BOARD OF COUNTY COMMISSIONERS
ORANGE COUNTY, FLORIDA
ADDENDUM NO. 3 / IFB Y15-7010-EB

ORANGE COUNTY ADMINISTRATION BUILDING HVAC - UPPER ROOF RTU
REPLACEMENT

- A. The bid opening date remains **September 1, 2015**.
- B. The purpose of this Addendum is to address ductwork modifications on the 5th floor, some detail additions and modify the RTU schedule as per the following drawings that replace existing drawings:

BID DOCUMENTS
 Drawing No.
M-105

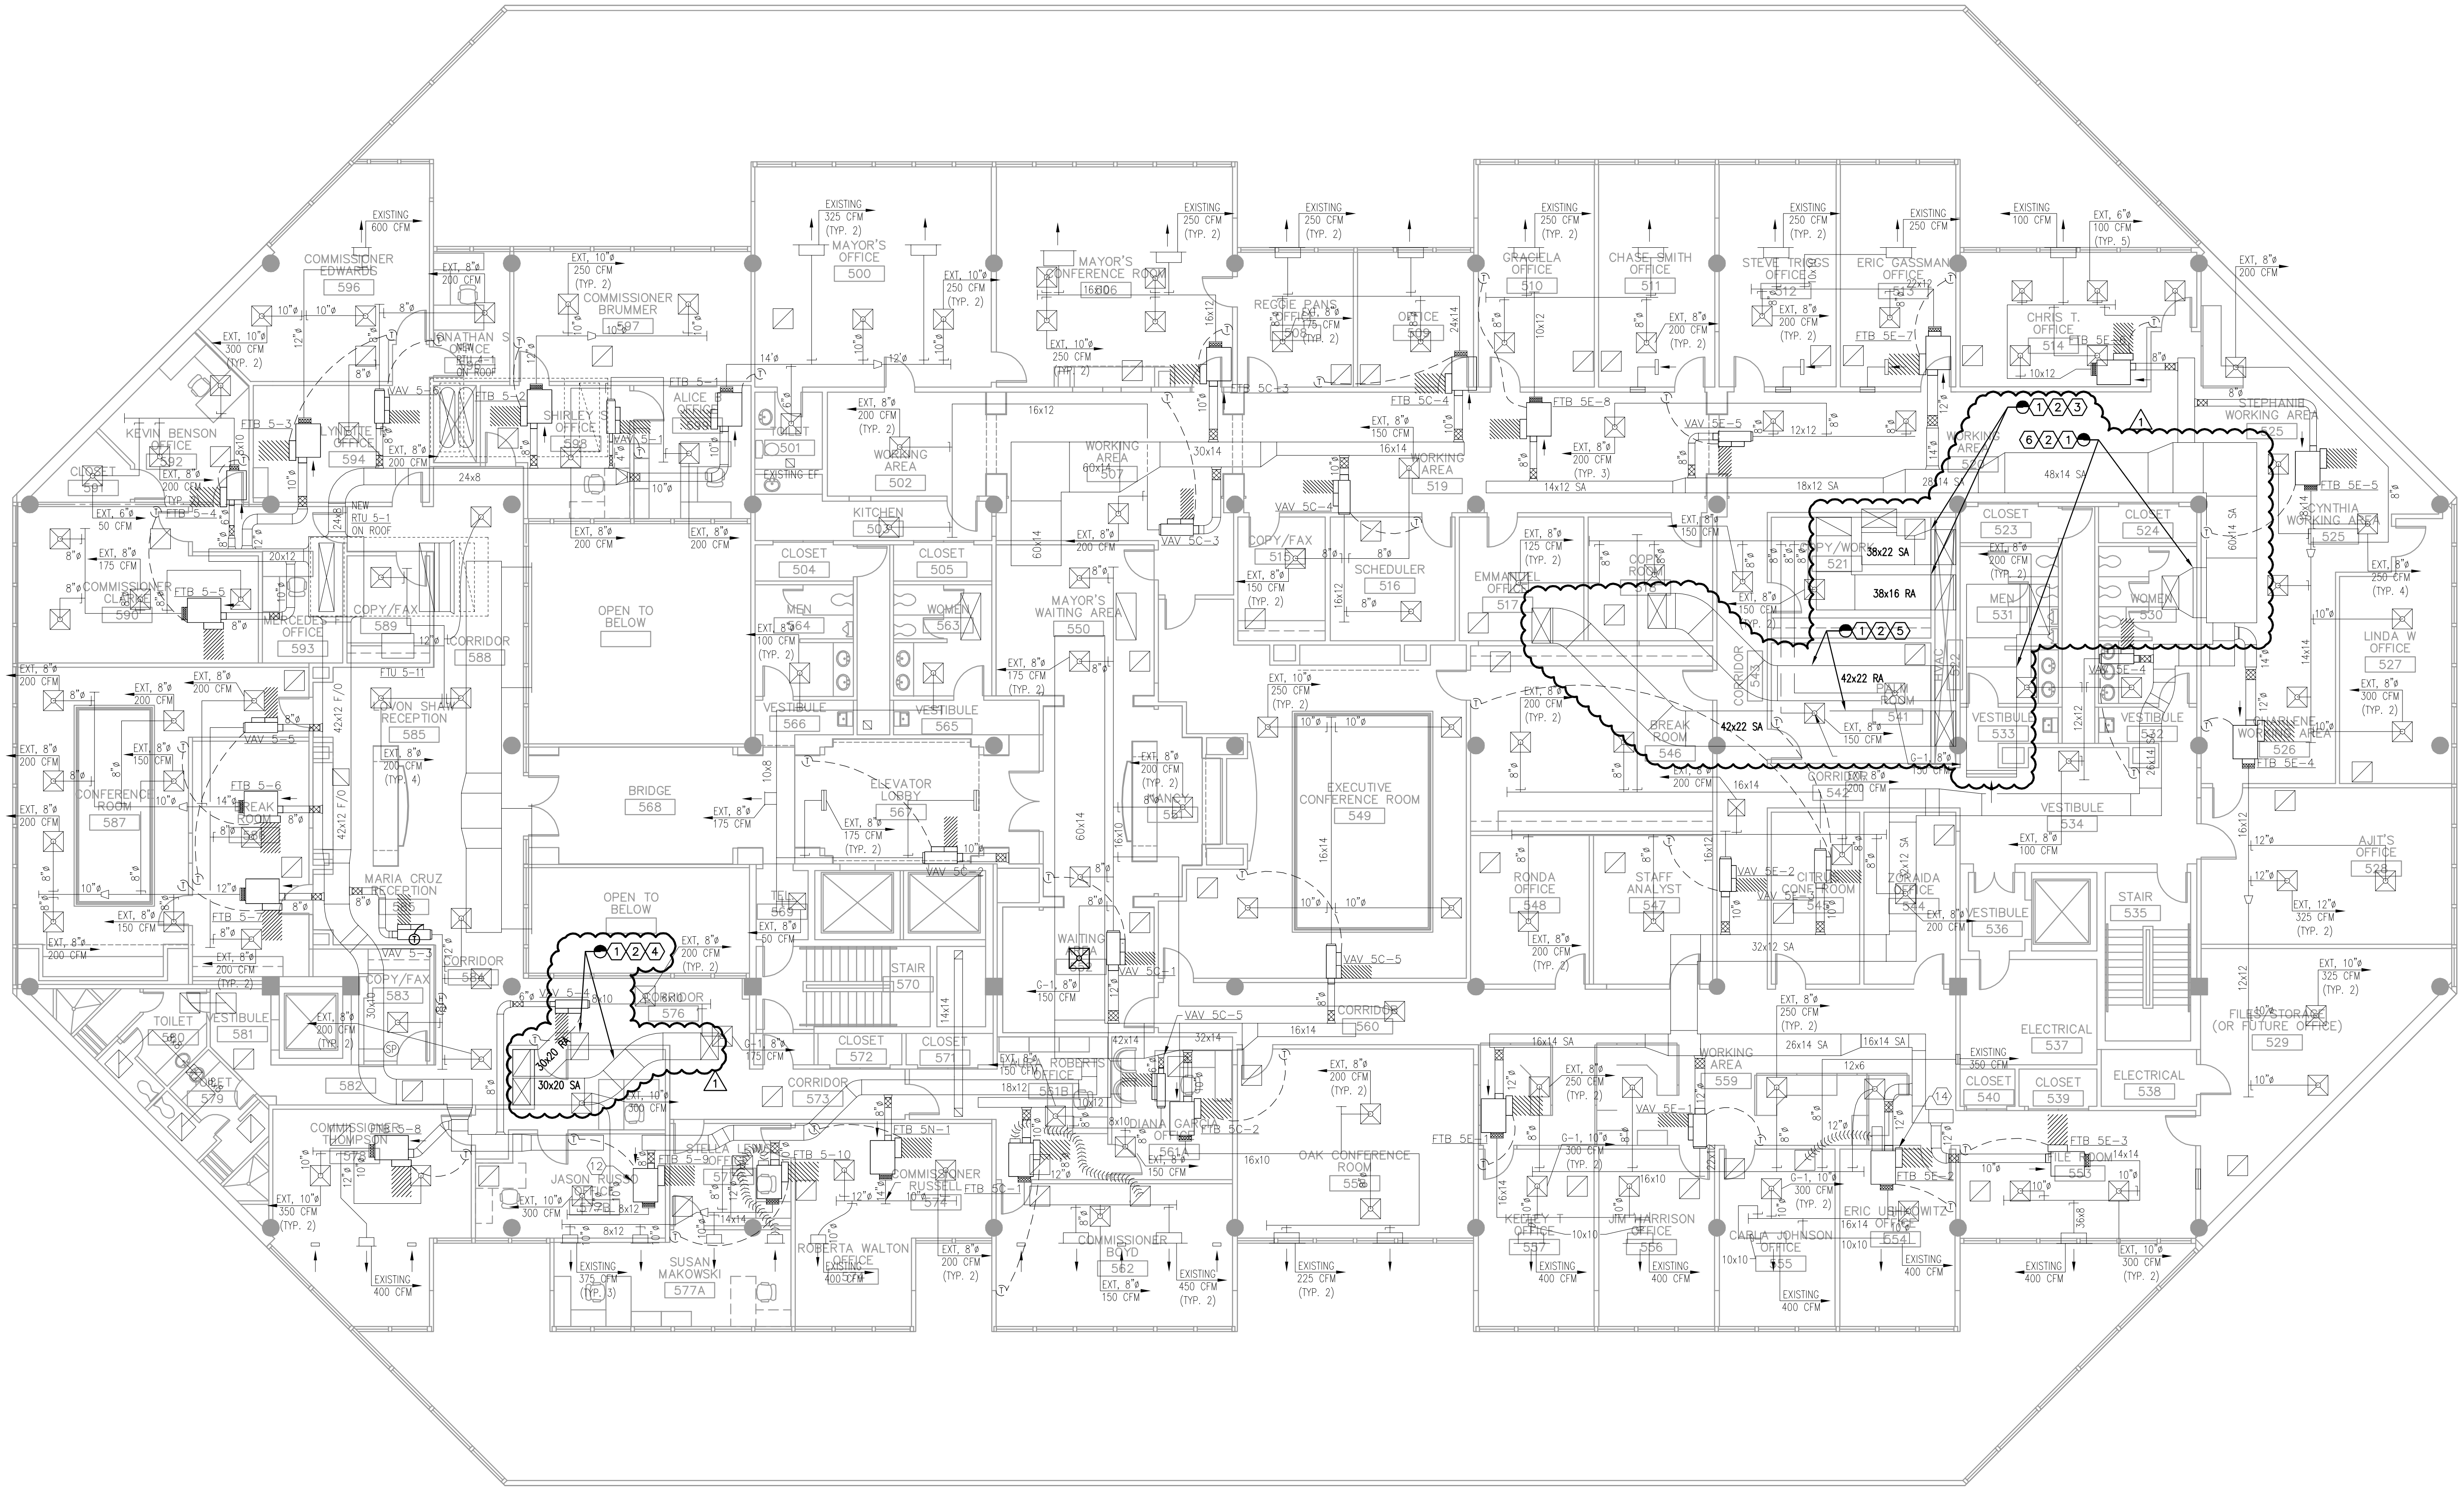
- 1. Replace Sheet M105 with revised Sheet M105 in its entirety.
- 2. Replace Sheet M106 with revised Sheet M106 in its entirety.
- 3. Replace Sheet M601 with revised Sheet M601 in its entirety.
- 4. Replace Sheet M901 with revised Sheet M901 in its entirety.
- 5. Replace Sheet E501 with revised Sheet E501 in its entirety.
- 6. Replace Sheet E601 with revised Sheet E601 in its entirety.

- THE PORTION OF EXISTING SUPPLY AND RETURN DUCTWORK ON THE 5TH FLOOR THAT IS CONNECTED TO RTU-3 IS TO BE PRESSURE TESTED, CLEANED AND REPAIRED WHERE LEAKS ARE FOUND. DUCTWORK JOINTS ARE TO BE SEALED AND RE-INSULATED.

- THE PORTION OF EXISTING SUPPLY AND RETURN DUCTWORK ON THE 5TH FLOOR THAT IS CONNECTED TO RTU-4C IS TO BE PRESSURE TESTED, CLEANED AND REPAIRED WHERE LEAKS ARE FOUND. DUCTWORK JOINTS ARE TO BE SEALED AND RE-INSULATED.

- THE PORTION OF EXISTING SUPPLY AND RETURN DUCTWORK ON THE 5TH FLOOR THAT IS CONNECTED TO RTU-4E IS TO BE PRESSURE TESTED, CLEANED AND REPAIRED WHERE LEAKS ARE FOUND. DUCTWORK JOINTS ARE TO BE SEALED AND RE-INSULATED.

6 EXISTING MAIN SUPPLY AND RETURN DUCTWORK ON THAT 5TH FLOOR THAT IS CONNECTED TO RTU-5E IS TO BE PRESSURE TESTED, CLEANED AND REPAIRED WHERE LEAKS ARE FOUND. DUCTWORK JOINTS ARE TO BE SEALED AND RE-INSULATED.
